Our Ref: S3126/KPR/24/013Lg

26 June 2025

**Rezoning from "Residential (Group D)" to "Residential (Group C) 1" Zone  
For a Proposed Residential Development  
at Various Lots in D.D. 104 and the Adjoining Government Land  
in Yuen Long, N.T.  
- S12A Amendment of Plan Application –  
TPB Ref.: Y/YL-MP/10  
Further Information No. 5**

**Figure 6.2 Proposed Statutory Notes for “Residential (Group C)1”**

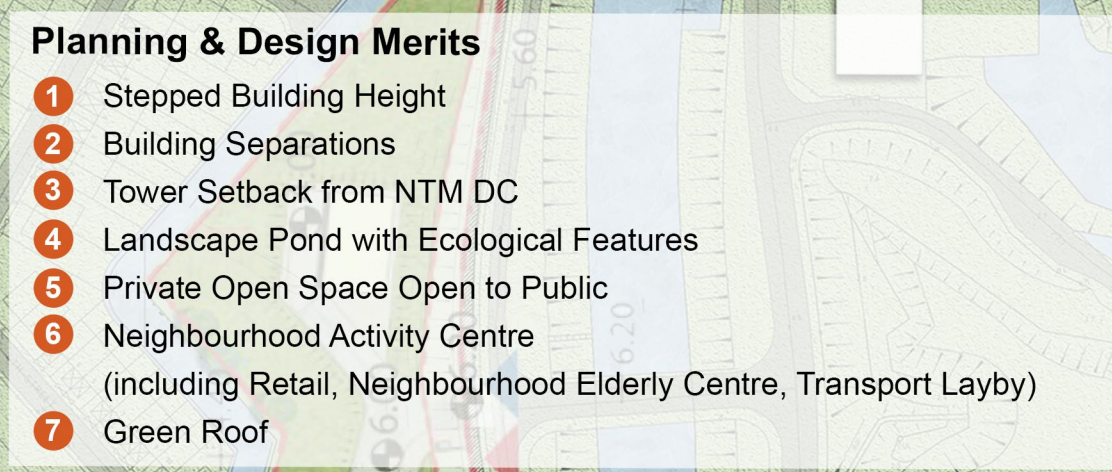
Further queries from DPO/FSS&YLE	Responses
Please confirm the provision of green ratio.	The Proposed Development Scheme will provide greenery area of a minimum of 30% of the site area in accordance with PNAP APP-152.
Please provide reasons of proposing "Private Club" and "Place of Recreation, Sports or Culture" uses as Column 1 Uses.	This is to allow greater flexibility in the range of services to be provided in the proposed Neighbourhood Activity Node (e.g. fitness center, arts studio, gymnasium, small-scale indoor recreation/sports centre (e.g. for privately operated indoor pickleball courts and padel courts), etc.). While these uses would attract a similar patronage as per the general "Shop and Services"/ "Eating Place" uses, no additional technical impacts would be anticipated. Figure 6.2 Proposed Statutory Notes for "Residential (Group C)1" has been updated accordingly (see attached).
Please explain how would the proposed building height (BH) be compatible with the BHs of the adjacent developments.	<p>The area is going to experience tremendous change in the coming years. NOL, Ngau Tam Mei Station and the first population intake of the comprehensive residential neighbourhood will all take place starting from 2034. The comprehensive residential neighbourhood near the Application Site will be 18 ha. in size and will provide 12,000 – 13,000 new flats (mainly private housing). The proposed plot ratio is about 6 and the building height is anticipated to be over 40 storeys. While these &gt;40-storey residential buildings have been considered compatible with the existing developments on the adjacent sites, the Proposed Residential Development on the Application Site with a building height of only 14 to 16 storeys should also be considered appropriate.</p> <p>In addition, the Indicative Development Scheme incorporates various design features tailored to the unique site context. These include a 0.5-hectare Landscape Pond with Ecological Features, tower setbacks from the Ngau Tam Mei Drainage Channel, and</p>
